The BULLETIN OF THE BEAUX-ARTS INSTITUTE OF DESIGN

THE BULLETIN OF THE
BEAUX-ARTS INSTITUTE OF DESIGN
MAY 1948 VOL. XXIV NUMBER FOUR SCHOOL YEAR 1947-1948

REPORT OF THE JURY - BY WILLIAM E. KATZENBACH

REPORT OF THE JURY - BY SIDNEY L. KATZ

FERNAND T. PIGO
PRINTING UNIT
73

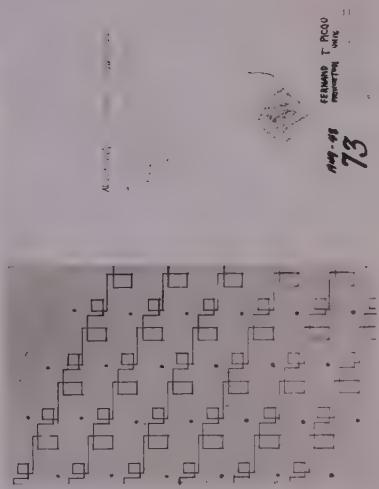
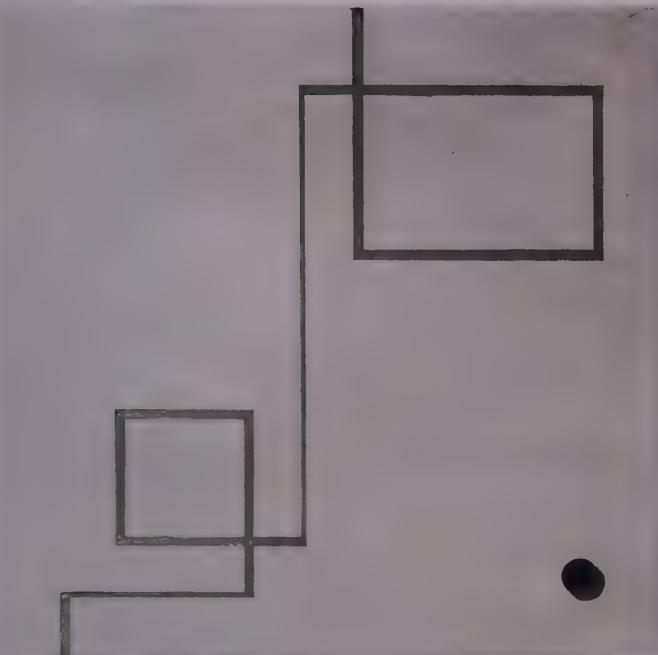
F.T.PICOU, PRINCETON UNIVERSITY - MENTION: ESPECIALLY LIKED BECAUSE WITH A MINIMUM OF DRAWING AND ECONOMY OF COLOR HE ACHIEVED A FEELING OF OPENNESS AND SPACE WHICH IS WELL ILLUSTRATED IN THE SMALL SCALE SKETCH SHOWING A NUMBER OF REPEATS. GOOD COLOR.

ERNEST R. NORMAN, JR.
UNIVERSITY OF ILLINOIS
BAID. CLASS A PROB 3
A PUBLISHING HOUSE.

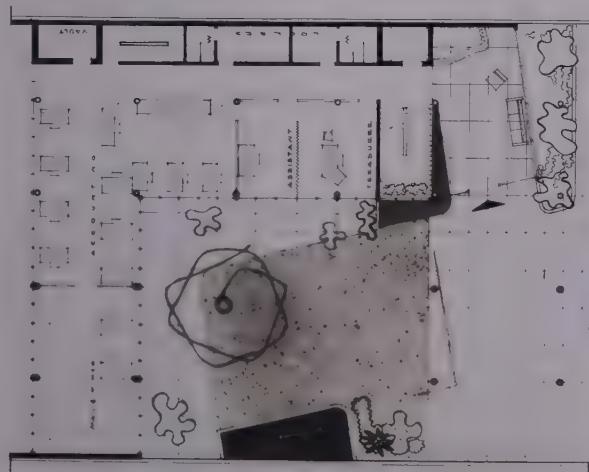
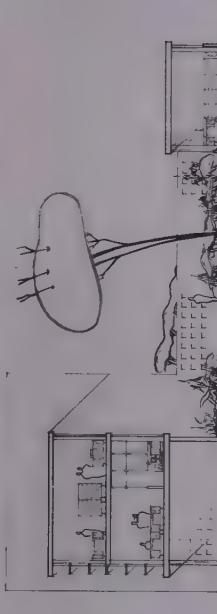
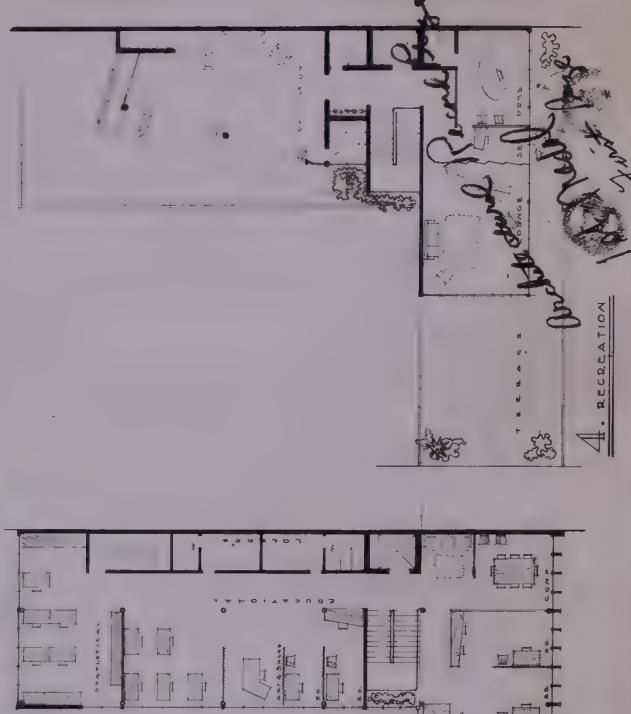
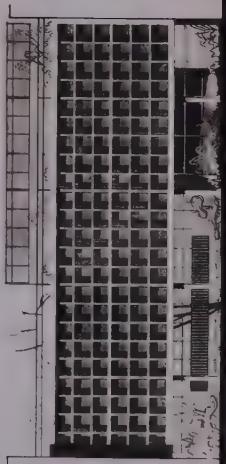
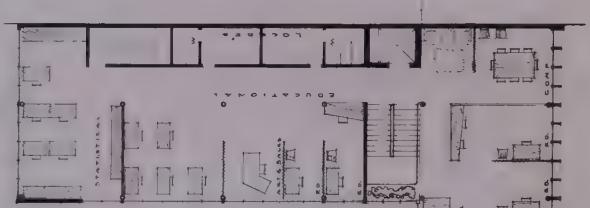
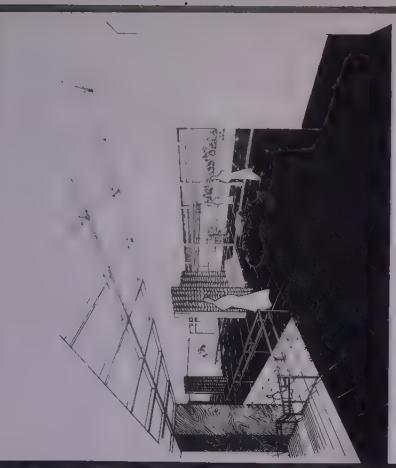
THE SECOND PRIZE PLAN BY E.R.NORMAN, JR., UNIVERSITY OF ILLINOIS, WAS ADMIREDFOR ITS COMPACTNESS, ECONOMY AND CONSISTENCY, THOUGH THIS WAS BOUGHT AT A PRICE. THIS WAS VIRTUALLY THE ONLY SUBMISSION THAT ENCOMPASSED THE WHOLE PLANT ON TWO FLOORS, AND EMPHASIZED THE DESIRED "ONE-BIG-FAMILY" NATURE OF THE ENTERPRISE. IT DID SO AT THE COST OF SOME DARK INTERIOR AREAS, ESPECIALLY IN DEPARTMENTS DEVOTED TO SALES AND STATISTICS. THERE WERE JURORS WHO CRITICIZED THE SMALL INTERIOR COURT, OTHERS WHO SUGGESTED IN MITIGATION THAT IT WAS ONLY ONE STORY DEEP. OTHERS COMPLAINED OF EDITORS DIRECTLY FACING THE STREET, THOUGH IT WAS ANSWERED THAT A HIGH BULKHEAD MINIMIZED THE DISTRACTION. CONFERENCE SPACE, THOUGH ADEQUATE, HAD TO BE AT A SLIGHTLY GREATER DISTANCE AWAY FROM SOME DEPARTMENTS THAN IN THE FIRST-PRIZE SCHEME, AND AGAIN THERE WAS CRITICISM OF MERE CURTAINS AS ENCLOSURE, WHERE PRIVACY OF CONVERSATION WOULD BE HIGHLY DESIRABLE. THE STRONG VIRTUE OF THE PLAN WAS ITS OBSERVANCE OF COMPACTNESS AND ECONOMY, IN AN EPOCH WHERE THESE COUNT STRONGLY.
